## STAFF RECOMMENDATION 2601 Oakland Avenue September 19, 2018

**Application:** New Construction—Addition and Detached Accessory Dwelling Unit;  
Partial Demolition

**District:** Belmont-Hillsboro Neighborhood Conservation Zoning Overlay

**Applicant:** Kaitlyn Smous, Nine 12 Architects

Figures 2 & 3 show the deck and the doorway that will be removed.

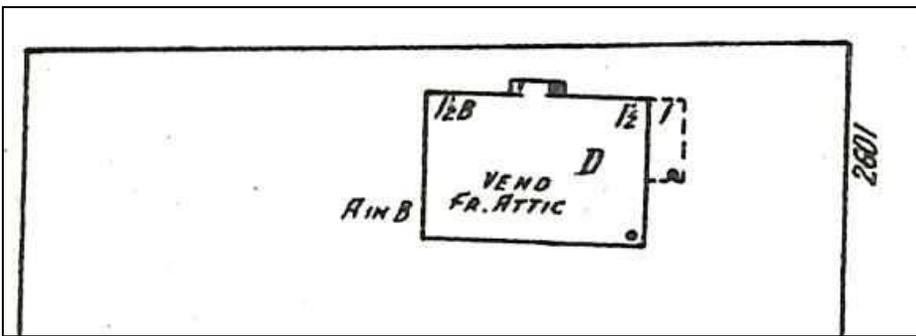
**Partial Demolition:** The applicant intends to remove a non-historic two-story deck on the left façade (Figures 2 & 3). The date of construction of the deck is not known, but it does not appear on the 1957 Sanborn Map (Figure 4). Staff finds that the two-story deck is not architecturally or historically significant and finds that its removal is appropriate. The applicant also intends to remove the existing door opening leading to this deck and replace it with a double window opening. This doorway is likewise not original and its removal will not affect the historic or architectural integrity of the historic house. The applicant will also remove an uncovered rear deck, which MHZC does not review. Staff therefore finds that the proposed partial demolition meets Section V.2. of the design guidelines, and does not meet Section V.1.

SITE PLAN

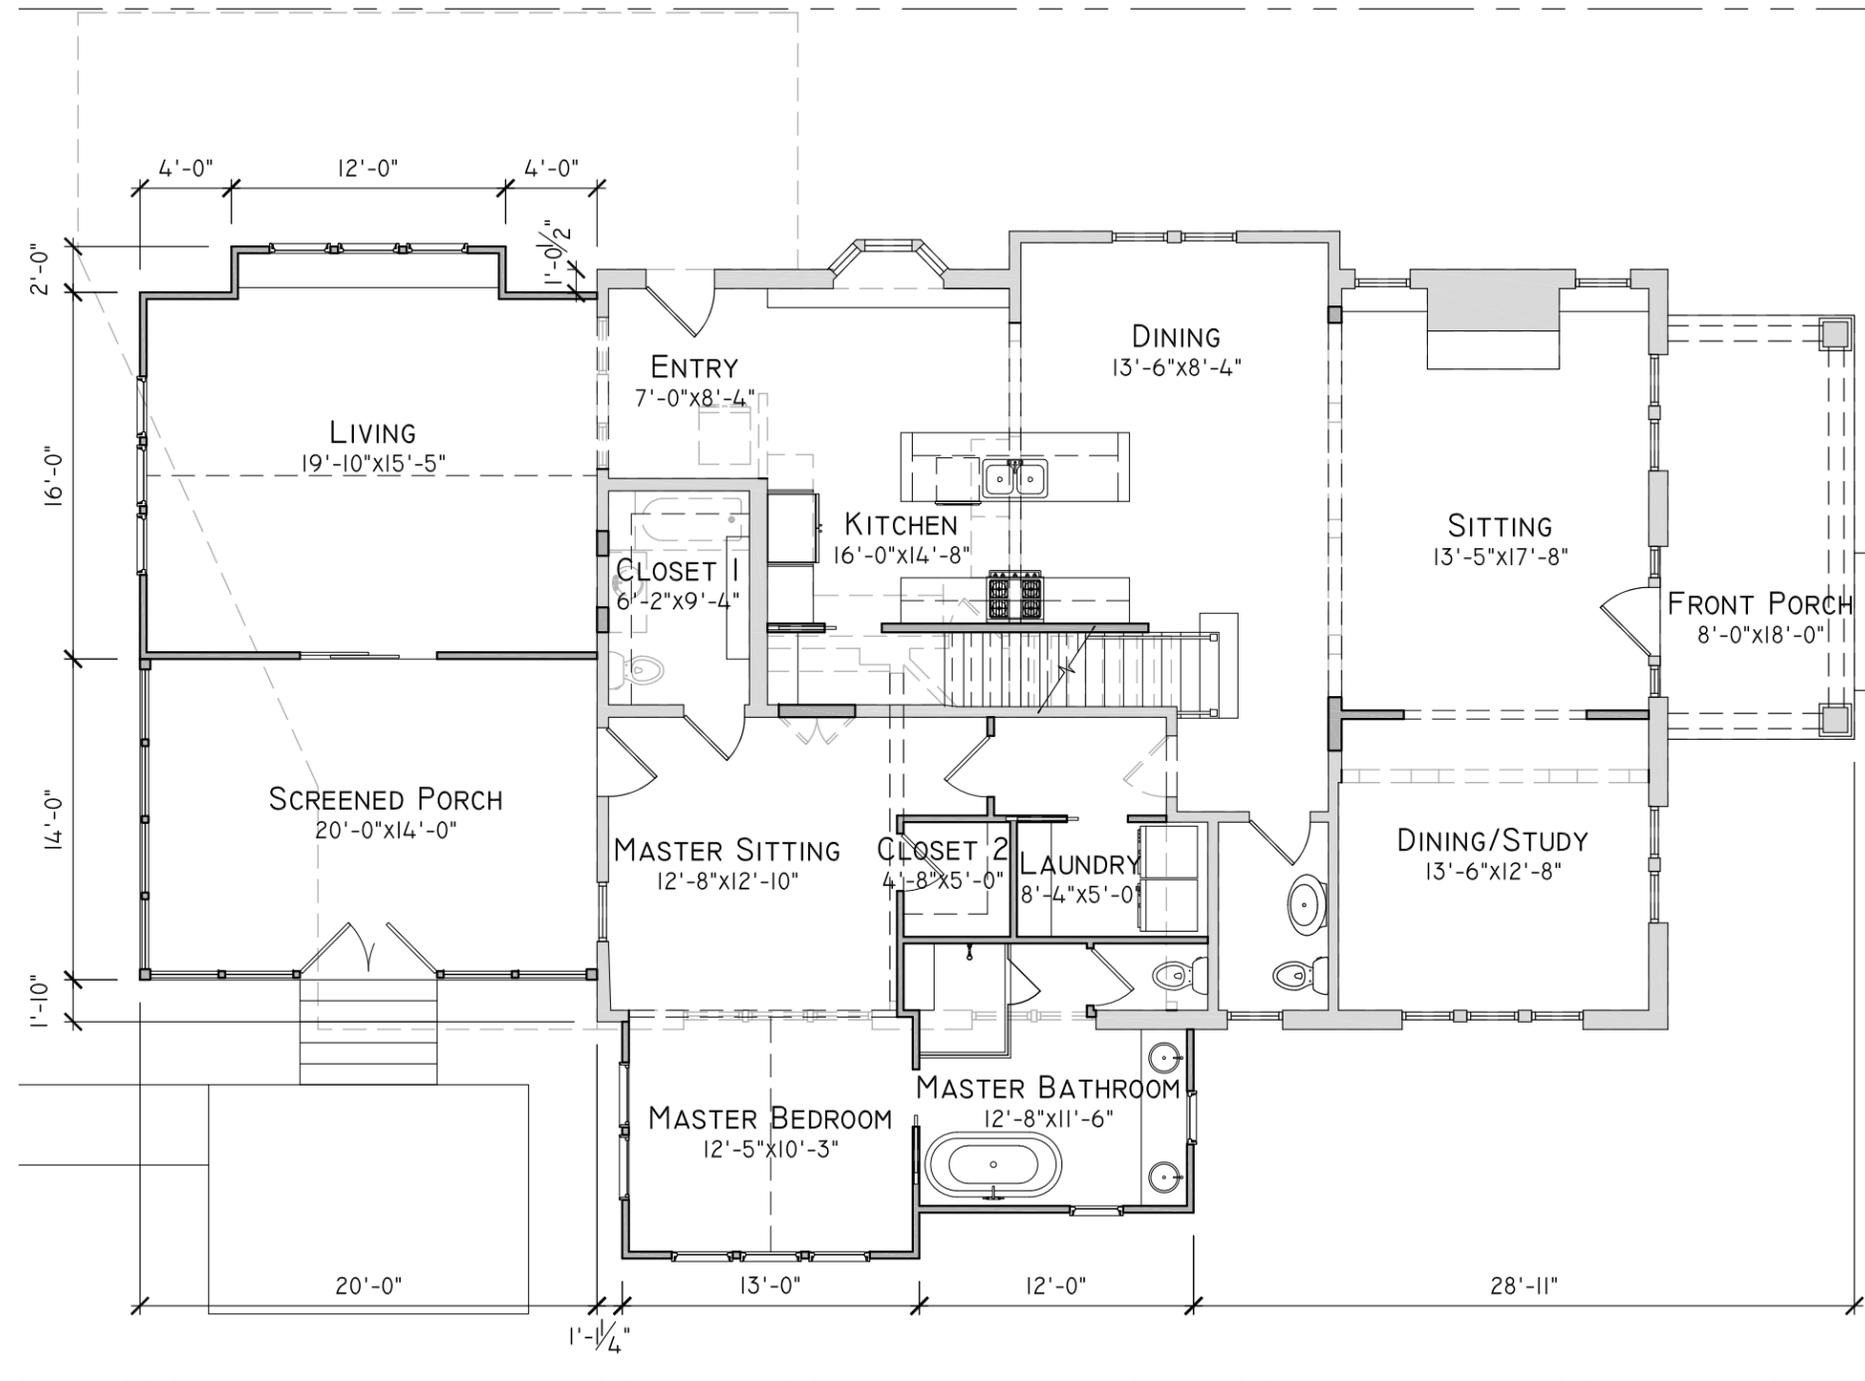
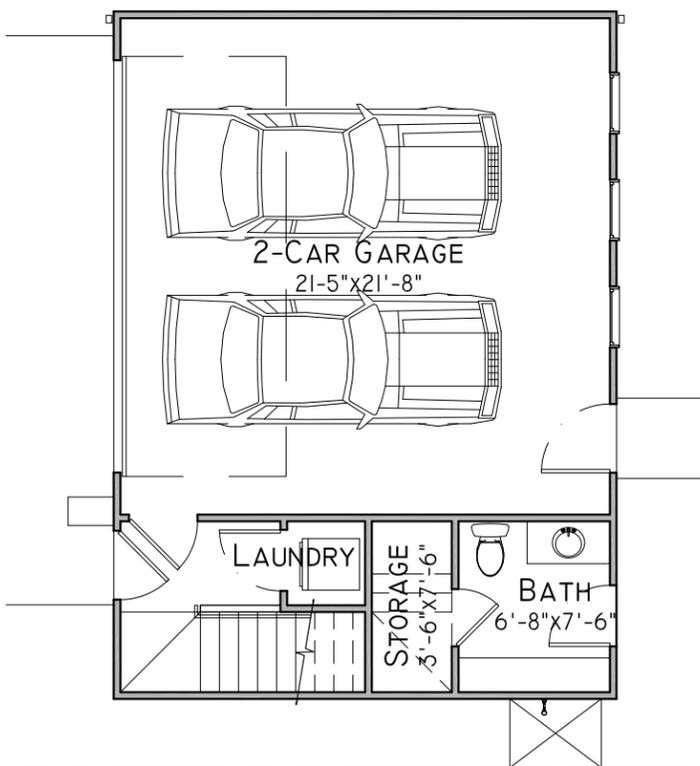
Setback & Rhythm of Spacing: The proposed additions meet all base zoning setbacks. The proposed side addition will be a minimum of five feet (5') from the left side property line, and the rear addition will be a minimum of ten feet (10') from the side street property line. The additions will be over sixty-five feet (65') from the rear property line. Because the side addition is pushed to the back half of the house, it will not affect the rhythm of spacing of historic houses on this block. Staff finds that the proposed additions meet Sections II.B.1.c. and II.B.2. of the design guidelines.

Appurtenances & Utilities: No changes to the site’s appurtenances were indicated on the drawings. The location of the HVAC and other utilities was also not noted. Staff recommends that the HVAC be located on the rear façade, or on a side façade beyond the midpoint of the house in order to meet Section II.B.1.h. of the design guidelines.
